**RE:** Revisions to application documents as a result of completeness review

I am writing to summarize the revisions we have made to our application as a result of the completeness review held on April 28, 2022. We have revised the existing and proposed site plans along with the lot coverage calculations and have outlined these revisions below. We have also included guidance received from DEP on the wash water discharge system:

HARVEST TIDE ORGANICS  
 304 PORK POINT ROAD  
 BOWDOINHAM, ME

EXISTING SITE PLAN	
DESIGNER:	W/JW
DATE:	2/7/2022
SCALE:	1" = 100'-0"
SHEET SIZE: 11" x 17" (ANSI B)	
PROJECT #:	21-110
SHEET:	P0

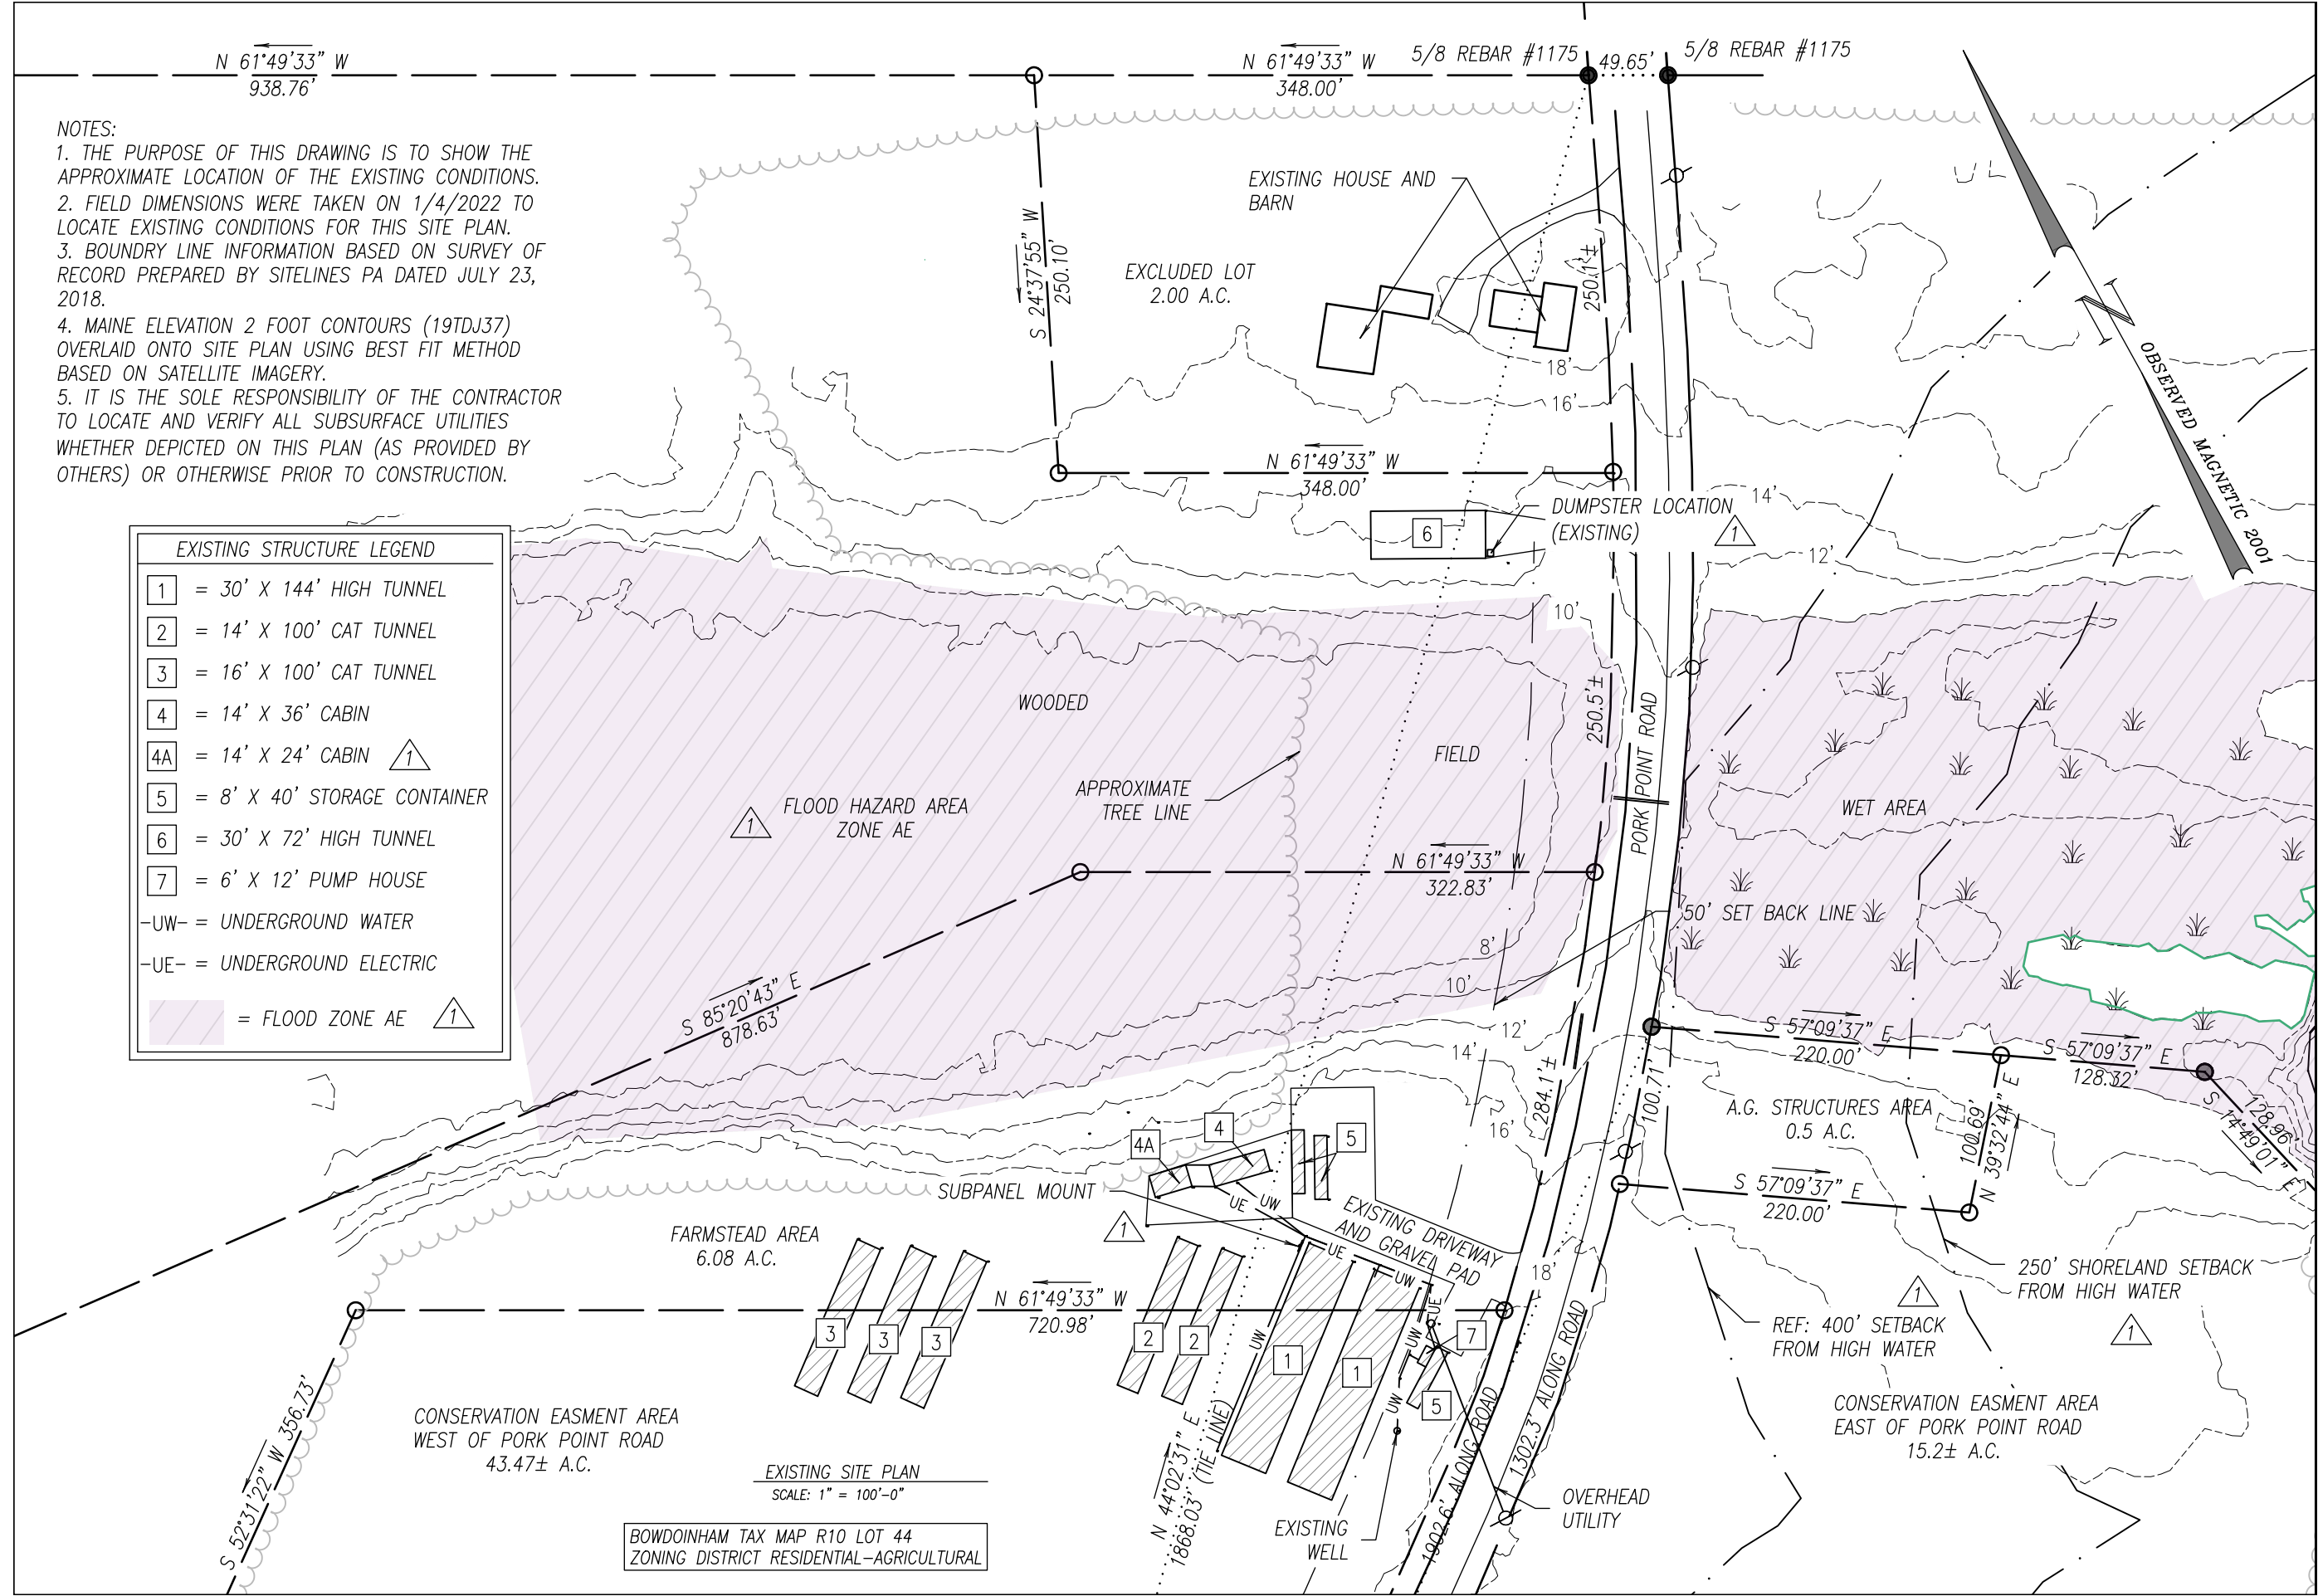
1. Existing Site Plan (R1):

- We have added the location of the existing dumpster where it is currently proposed to remain in place.
- We have added the residential-agricultural district note.
- We have added the 250' shoreland zone setback based on the high water line shown on the Sitelines survey dated 7/23/2018.
- We have added a 400' shoreline setback for reference as the 250' setback will not show on the proposed site plan at current scale.
- We have overlaid the flood hazard area as requested.
- The applicant has added another employee cabin and has extended the gravel pad from the driveway to encompass both cabins. We have shown these on the plan along with electrical and water lines connecting the two cabins.

**PROPOSED SITE PLAN**

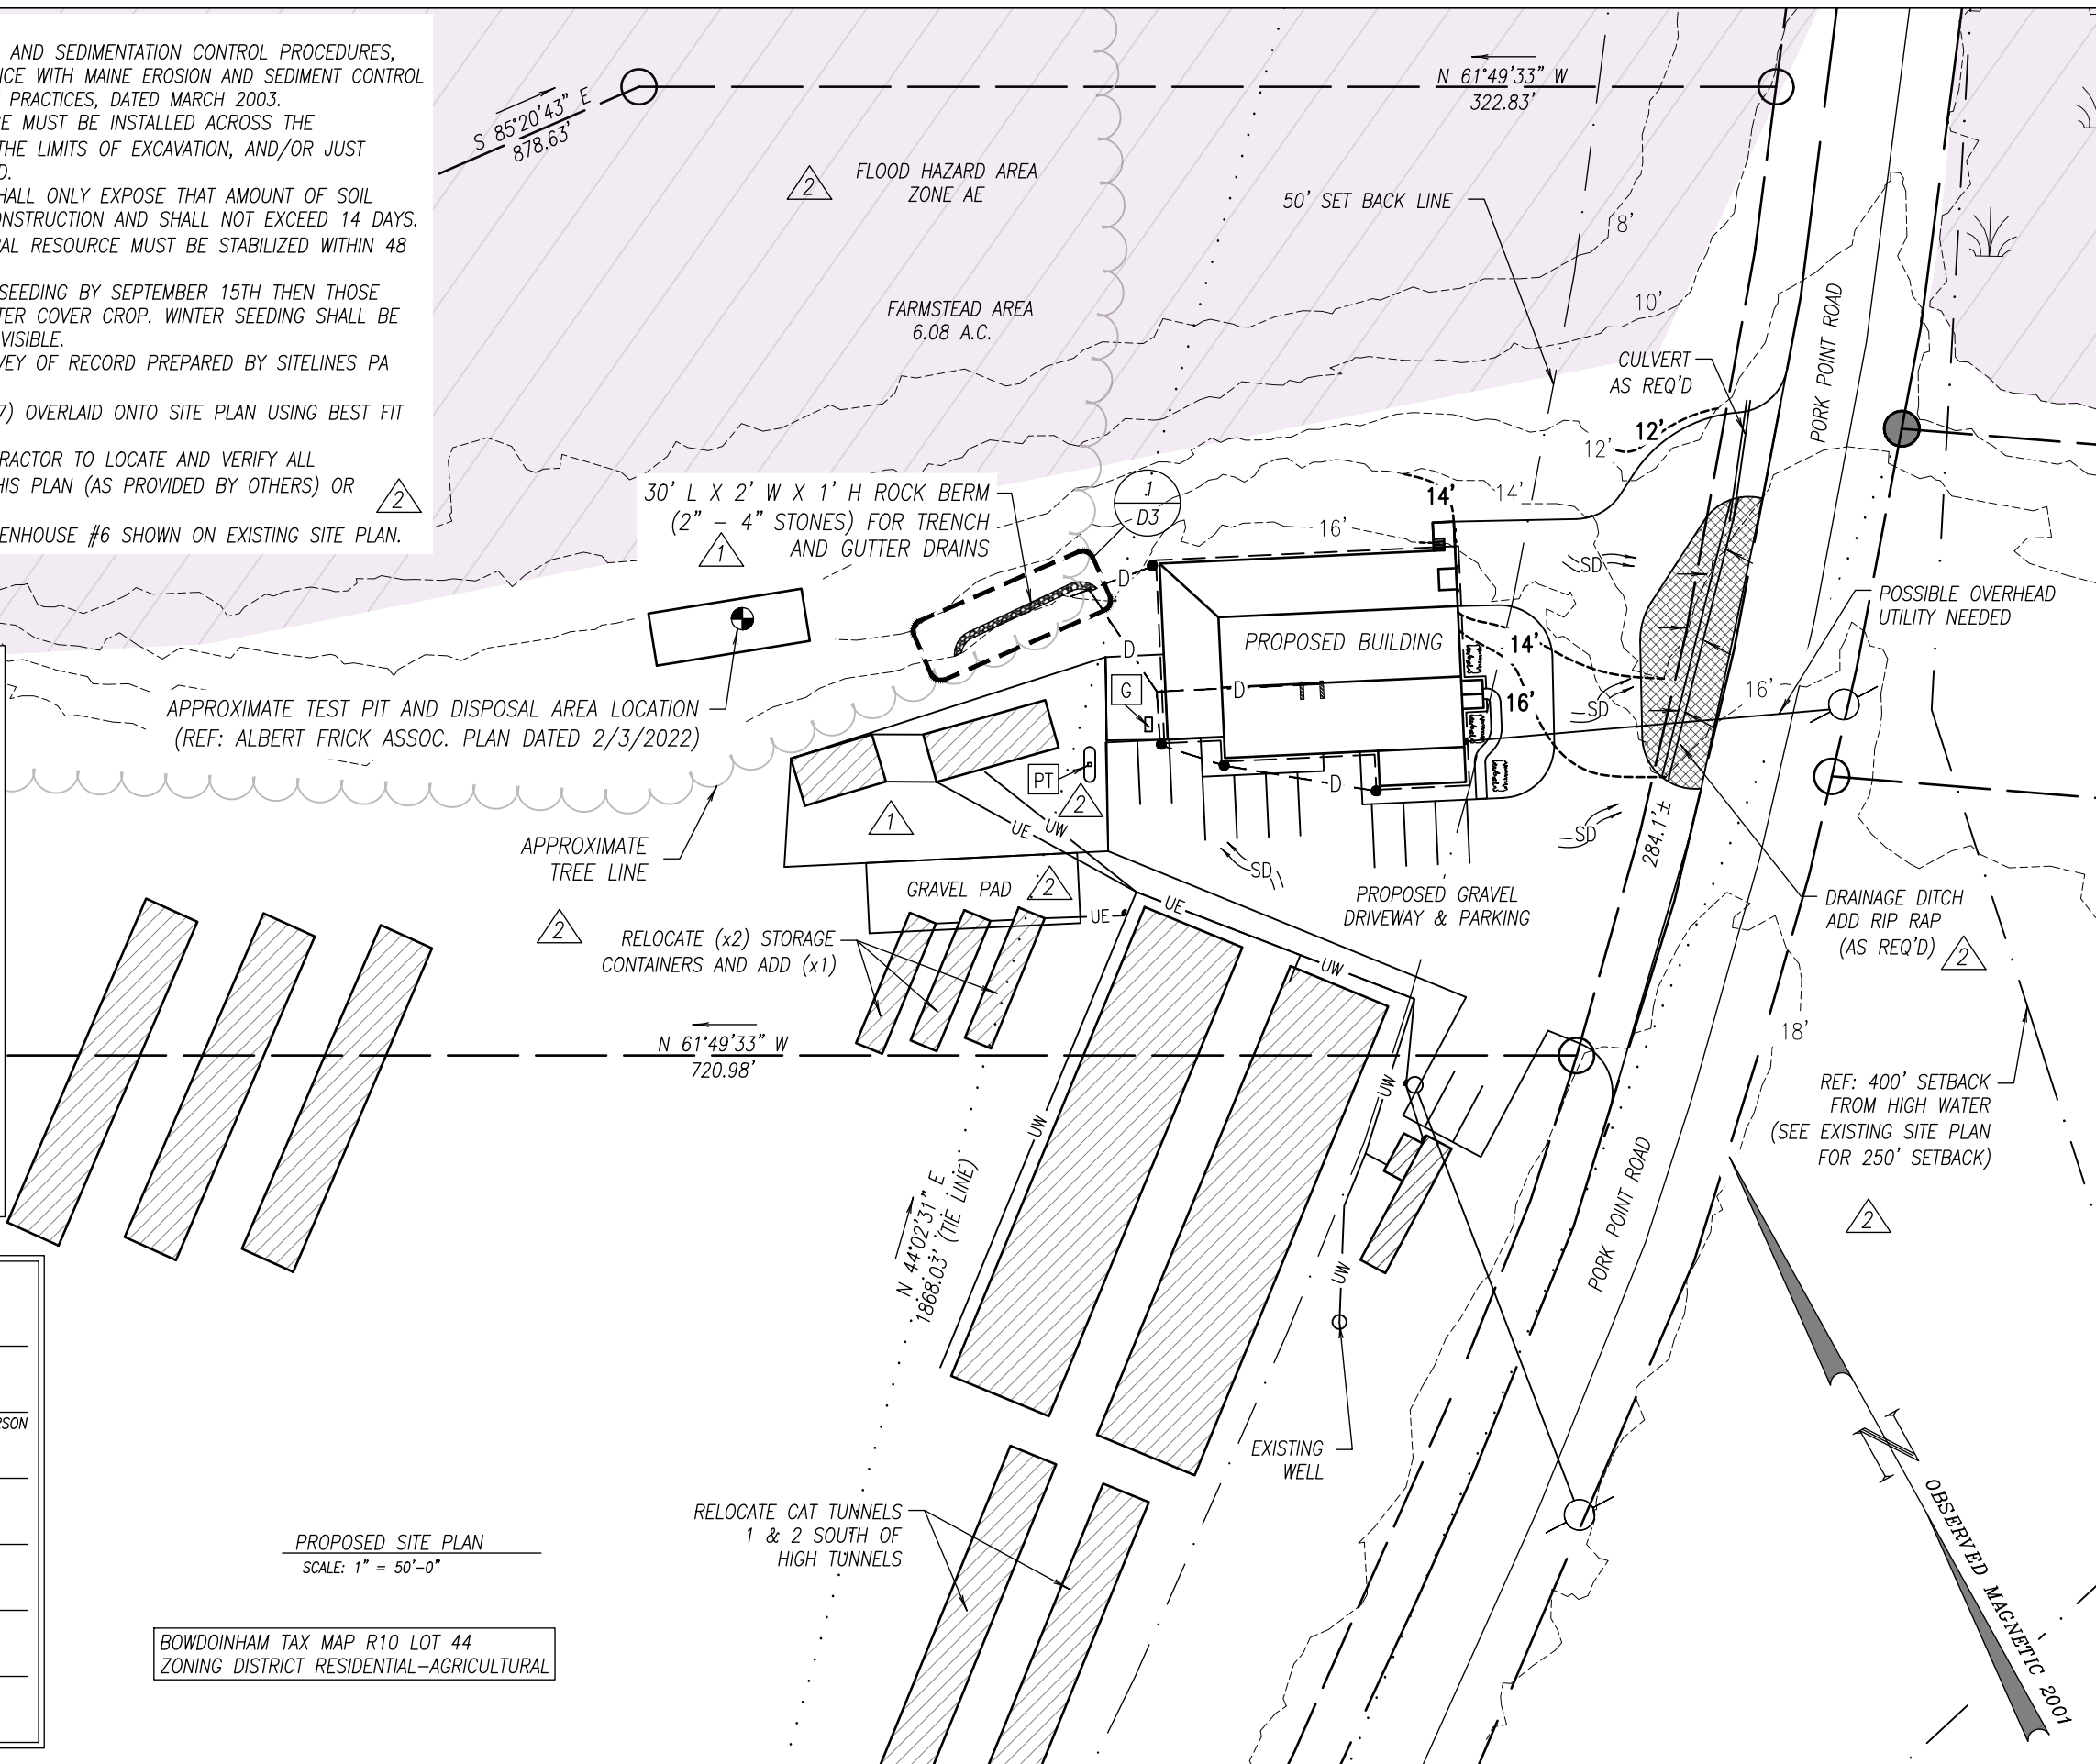
2. Proposed Site Plan (R2):

- We added a note that the existing dumpster is proposed to stay in place as shown on the existing site plan.
- We have added a gravel pad behind the proposed building for a future generator which will be buffered from view by the building.

- We have added the location of the propane tank which is proposed to be buried which will buffer it from view.
- We have added a gravel pad leading to the relocated storage containers which we are now proposing to add another container and run electricity to each of them.

- We have added a 400' shoreline set back for your reference along with a note to see existing site plan for 250' shoreland zone set back as requested.

- We have overlaid the flood hazard area as requested.
- We have added surface drainage symbols to the driveways leading to the loading docks and have added further detail to the drainage ditch intended to catch the surface drainage and direct it to the culvert and on to the vegetated area below where surface drainage is currently directed.

- We have added the residential-agricultural district note.
